SERVICE INFORMATION BULLETIN

HOOD DAMPER SHAPE CHANGE

This document is to inform dealers and workshops of the design change to the hood damper, support bolt and the addition of a support collar.

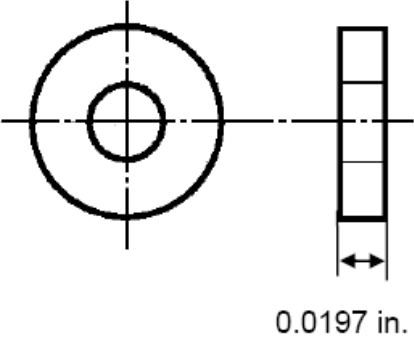
- A) The shape of the hood support will be changed.
- B) The design of hood support bolt will be changed.
- C) The support collar will be added.

DESCRIPTION	CURRENT PART	NEW PART
Support assembly, hood	S534401010	53440E0020
Bolt, hood support	SZ94052112	53443E0010
Support assembly, hood		0.043 in. 
Bolt, hood support		 0.041 in.

DESCRIPTION	CURRENT PART	NEW PART
Collar, support	N/A	45813E0010
Collar, support		 <p>0.0197 in.</p>

The new part is interchangeable with the current part as a set.

The current parts cannot be used with the new parts.
